Technical Peer Review – District Wide Regulation Model, Version 2 Southwest Florida Water Management District

Peer Review Panel

In the summer of 2008, the District initiated a voluntary peer review of DWRM2. The purpose of the peer review was to provide a critical, constructive, technical evaluation of DWRM2 and the FTMR procedure. The peer review was performed to determine the model's capacity to accurately simulate impacts to water resources of the District. Because DWRM2 was developed specifically for use in FTMR applications for water-use permit applications, the panel focused on the model's capacity to accurately simulate drawdown and changes in surface-water boundary condition flows at a combination of regional and FTMR scales instead of the model's capacity to simulate absolute water-level elevations. Specific peer review objectives stated in the scope of work (SWFWMD, 2008) for the peer review include determining whether DWRM2 is:

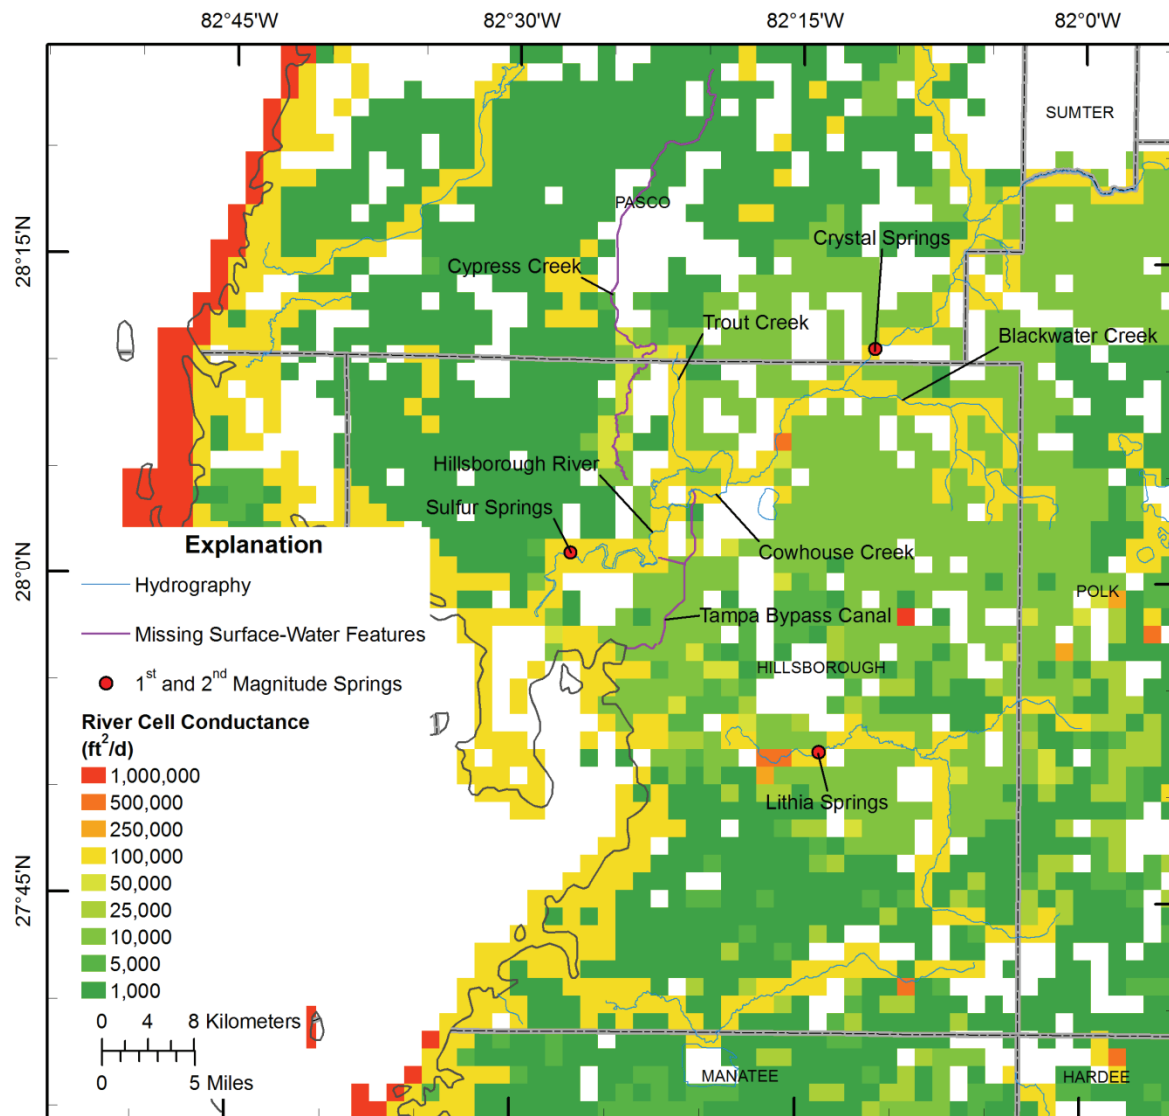
Surface-water features that are missing in the model conceptualization include Cypress Creek and the Tampa Bypass Canal (TBC) (Figure 1). These and other surface-water features are missing because they were not included on the 1:250,000 DLG. These features are hydrologically important, and should be included to represent ground-water/surface-water interactions at these locations. The TBC is a major hydrologic feature with an average SAS and UFA base-flow discharge of approximately 40 cubic feet per second (ft^3/s). The TBC is also an example of a surface-water feature that needs to be represented as a direct connection between the UFA and the surface water system, as the confining unit (ICU) overlying the UFA was breached when the TBC was constructed.

Crystal Springs is another major hydrologic feature that was not included in the conceptualization of DWRM2 (Figure 1). The spring is a second magnitude spring with an average flow rate of $60 \text{ ft}^3/\text{s}$ (Scott and others, 2004) and is a major source of base flow in the Hillsborough River. Hillsborough River base-flow targets are affected because the spring was not included in the model conceptualization. The spring flow also has a prominent effect on UFA water-levels in the vicinity of the spring that is not accounted for in the current model conceptualization.

Figure 2 IAS permeable zone 2 (PZ2) permeability ranges in a) DWRM2 and b) Knochenmus (2006). PZ2 extends throughout the model domain in DWRM2 but represents ICU or UFA properties outside of the approximate extent of the IAS.

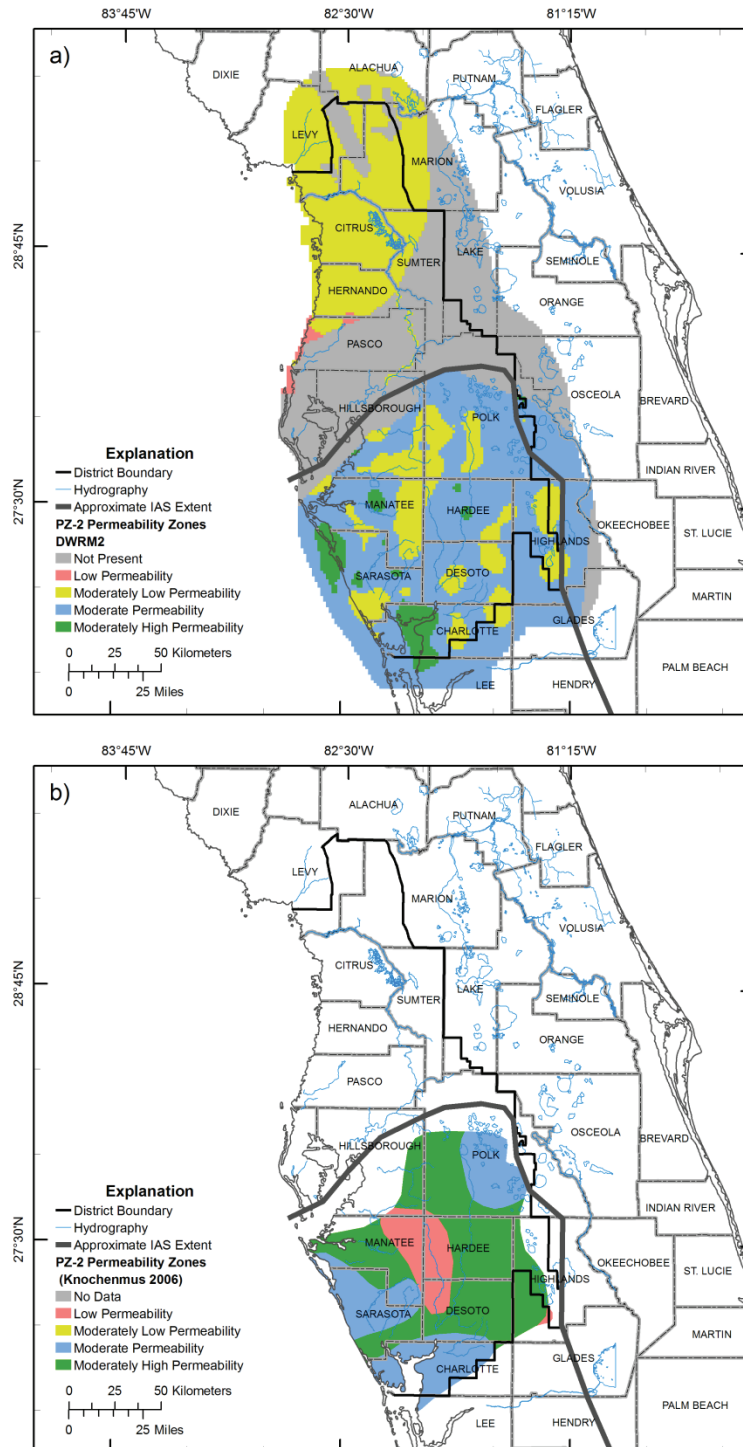
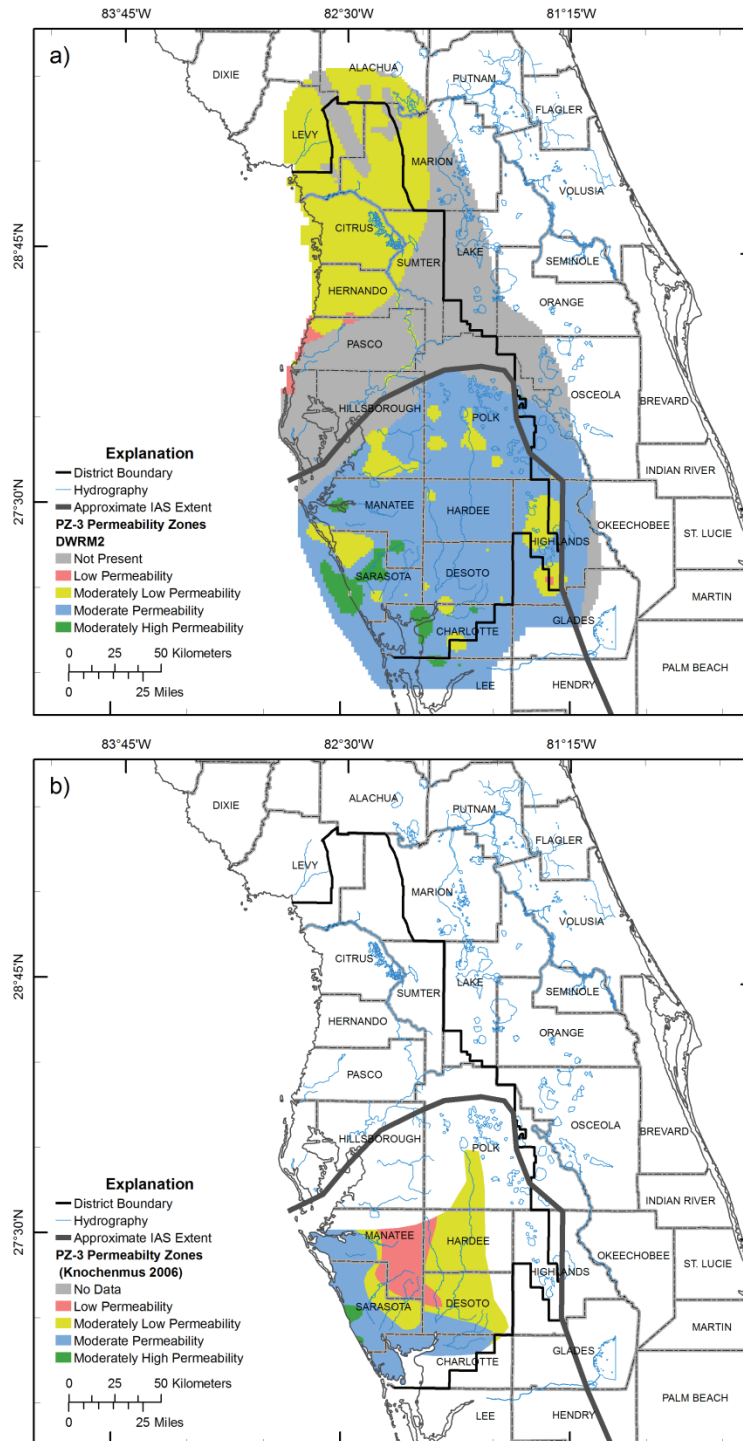
IAS transmissivities in DWRM2 do not correspond to the general transmissivity classifications in Knochenmus (2006) (see Figure 2). Low, moderately low, moderate, and moderately high permeabilities correspond to transmissivities less than 100, between 100 and 1,000, between 1,000 and 10,000, and between 10,000 and 100,000 ft²/day, respectively. PZ2 and PZ3 in DWRM2 are predominantly in the moderate permeability range (see Figures 2 and 3), but the moderately low permeability range covers a major portion of the area described by Knochenmus (2006). Aquifer parameters for PZ2 and PZ3 should be revised to incorporate data from Knochenmus (2006) in the regularization process.

Figure 4 UFA transmissivity in a) DWRM2 and b) Andrews (1990).

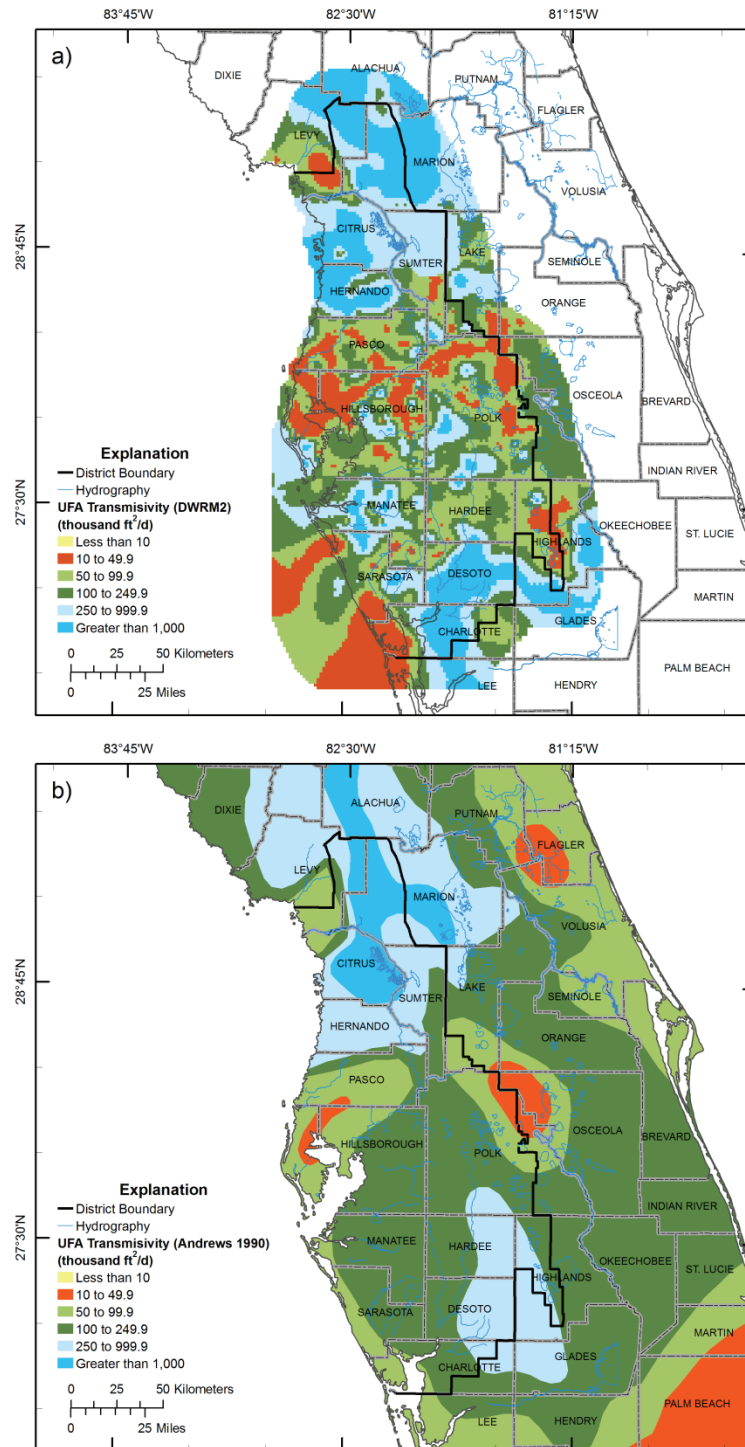
Comparison of UFA transmissivities in DWRM2 with Andrews (1990) are shown in Figure 4. In general, there is more heterogeneity in the transmissivity of the UFA in DWRM2 than the heterogeneity shown in Andrews (1990), but this is not necessarily a major concern for the model as a whole. Some areas that should be further evaluated and explained, if possible, are southern portions of the model domain with exceptionally high transmissivities, and areas in the vicinity of the Hillsborough River with relatively low transmissivities. It would also be beneficial if a depositional, post-depositional, diagenetic, and/or hydrogeologic hypothesis could be put forward to explain the spatial transmissivity patterns observed in the central to southern portions of the model domain.

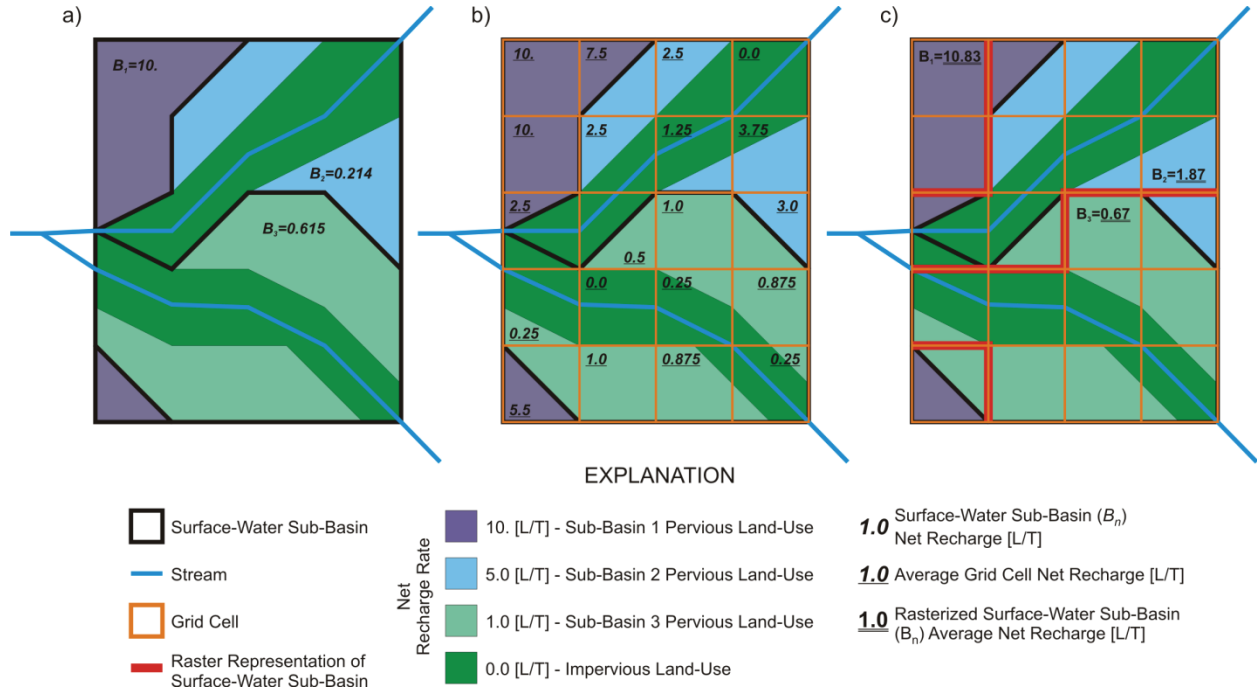
To accurately apply net recharge data from Geurink and others (2000), net recharge rates in DWRM2 should be adjusted based on the proportion of impervious surface-water features in each sub-basin (approximately 25 to 30%). For example, net recharge used in the DWRM2 in northeastern Hillsborough County is shown in Figure 6 grouped according to net recharge rates. The net recharge data used in DWRM2 vary by sub-basin and are equivalent to net recharge rates for upland areas in Geurink and others (2000). Proper scaling of net recharge data would reduce net recharge rates applied in DWRM2 and would likely eliminate the need for many conceptual drains currently required to prevent conditions where water above land surface in DWRM2 is simulated erroneously. Drains and areas with water above land surface are discussed in more detail in the following sections. Two possible approaches for mapping net recharge data for surface-water sub-basins to DWRM2 grid cells are shown in Figure 7 and are described below.

Scaling to account for net recharge in pervious areas could be done on a cell-by-cell basis, as shown in Figure 7b, which would maintain volume at the grid scale. This scaling would cause the net recharge array to vary dramatically across the DWRM2 domain. The cells covered by surface-water features would, therefore, have no recharge assigned, whereas the cells covered by uplands would use the scaled upland rate. The net recharge for individual grid cells is calculated using

An alternative approach to distributing cell-by-cell net recharge data in DWRM2, as shown in Figure 7c, would be to scale sub-basin average areal-weighted pervious and impervious net recharge rates using sub-basin areas in the watershed-scale model and the rasterized form of the basins in DWRM2. The scaling required to conserve volume between the vector-based, sub-basin polygons and raster-based sub-basins in DWRM2 is

Because the proportion of upland and wetland land-use and the contribution of each surface-water sub-basin can be developed on a cell-by-cell basis, it is recommended that **equation 1** be applied in DWRM2. This approach will result in the most accurate representation of net recharge in DWRM2 and is

Figure 8 Conceptual response of net ground-water recharge to rainfall. Approach used in transient DWRM2 simulations is shown in black. Alternate linear and non-linear approaches are shown in red.

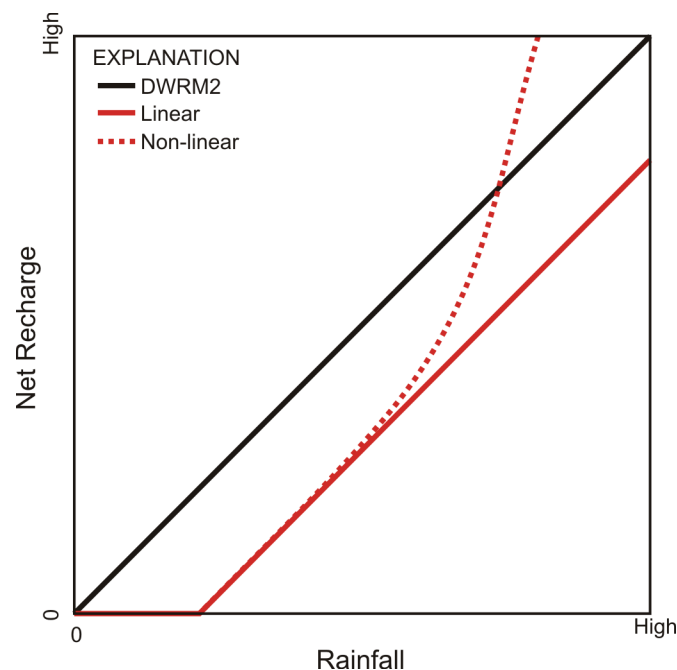
The current approach for distributing net recharge in the transient model assumes that there is a linear relation between monthly rainfall amounts and monthly net recharge. In reality, it is likely that low rainfall rates do not generate any recharge (for example, all of the rainfall is converted to evapotranspiration). Furthermore, net recharge rates may be a linear or non-linear function of rainfall rates. An example of such a relation between rainfall and net recharge rates is shown in Figure 8.

Use of an alternate approach for relating net recharge to rainfall would likely improve the ability to calibrate storage parameters and match low water levels in dry periods; accurate storage parameters and the ability to simulate water levels during dry conditions are both critical for transient FTMR simulations.

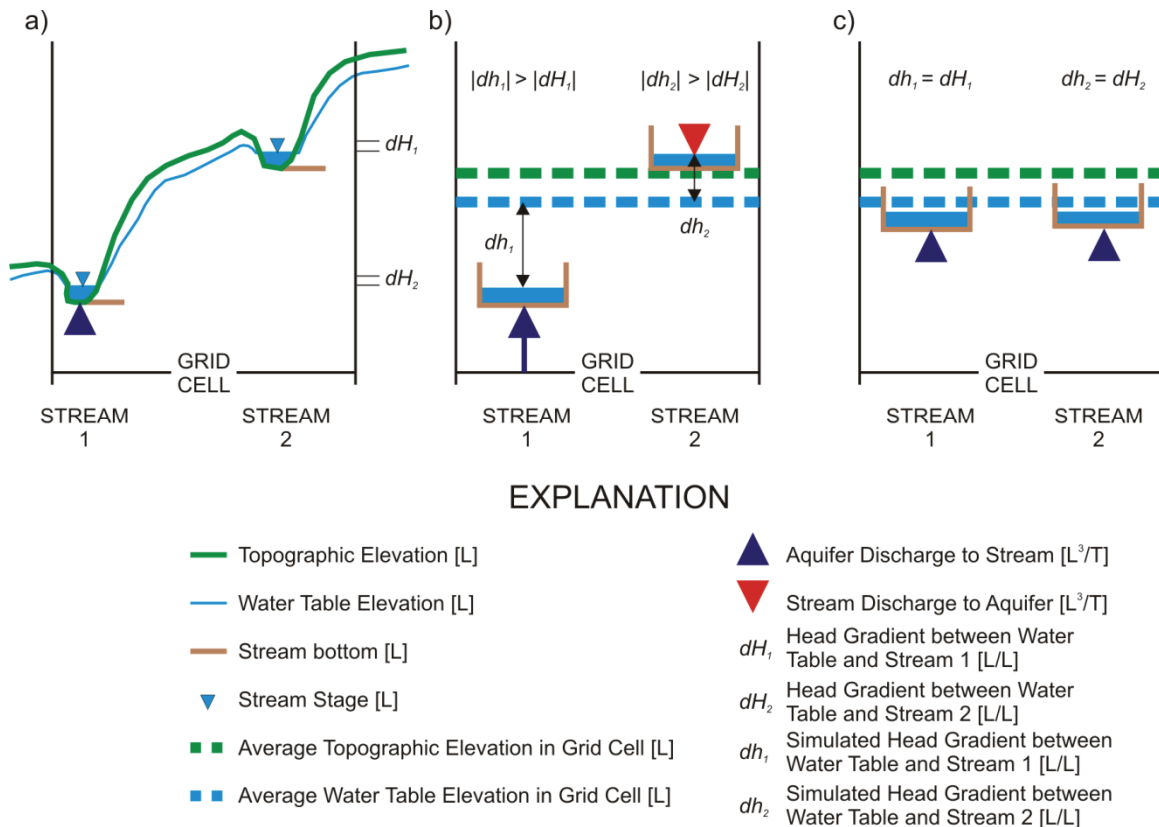
To accurately simulate the connection between the ground-water system and surface-water features, the base elevation for surface-water boundary conditions should be vertically adjusted. The approach that should be followed to accurately simulate ground-water/surface-water exchanges is shown graphically in Figure 11. Without adjustment of the base elevation of boundary conditions, simulated flow may be under-predicted (simulated flow is less than observed flow) or over-predicted (simulated flow is greater than observed flow) and adversely affect simulated water levels and water budgets.

automatic calibration process in DWRM2. It is recommended that water-level data should be shifted to the local grid cell datum (see Figure 11) or DTW targets be used instead of absolute SAS water-level elevations where DTW data are available.

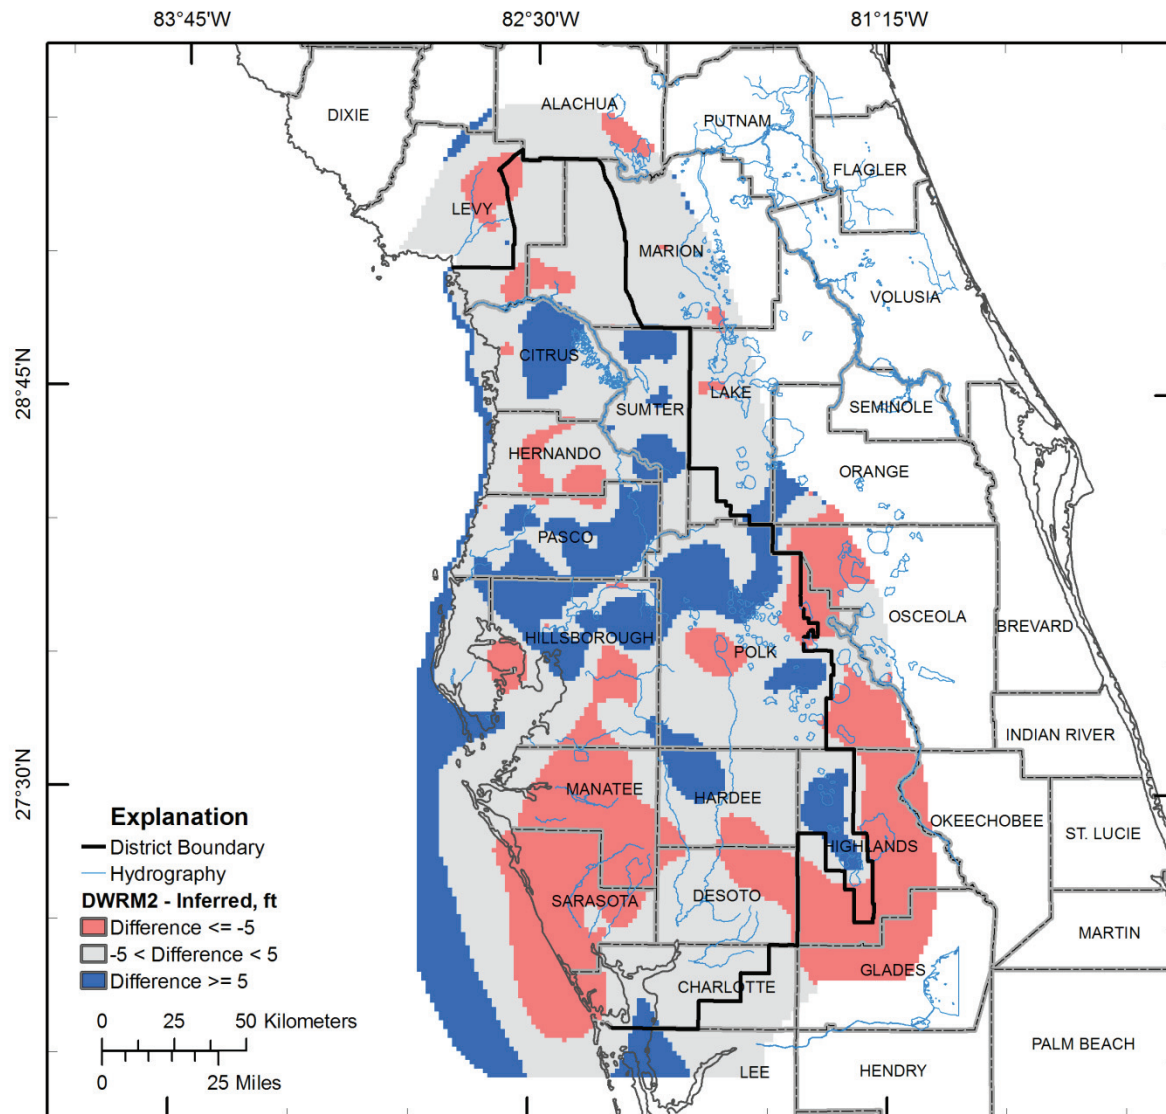
A comparison of simulated UFA potentiometric-surface contours to the pre-development UFA potentiometric contours developed by Johnston and others (1980) is shown in Figure 13. The simulated UFA potentiometric surface is more than 5 ft lower than indicated by Johnston and others (1980) in portions of Alachua, Levy, and Putnam Counties and throughout much of the SWUCA. The simulated UFA potentiometric surface is more than 5 feet greater than indicated by Johnston and others (1980) in the Hillsborough and Withlacoochee River Basins and portions of Hardee, Highlands, and Polk Counties. Over-predicted UFA heads (simulated water levels higher than inferred levels) are a consequence of inaccurate application of the net recharge data of Geurink and others (2000) in DWRM2. Differences between simulated and inferred, contoured pre-development UFA water levels may also be an indicator of errors with calibrated model parameters in DWRM2.
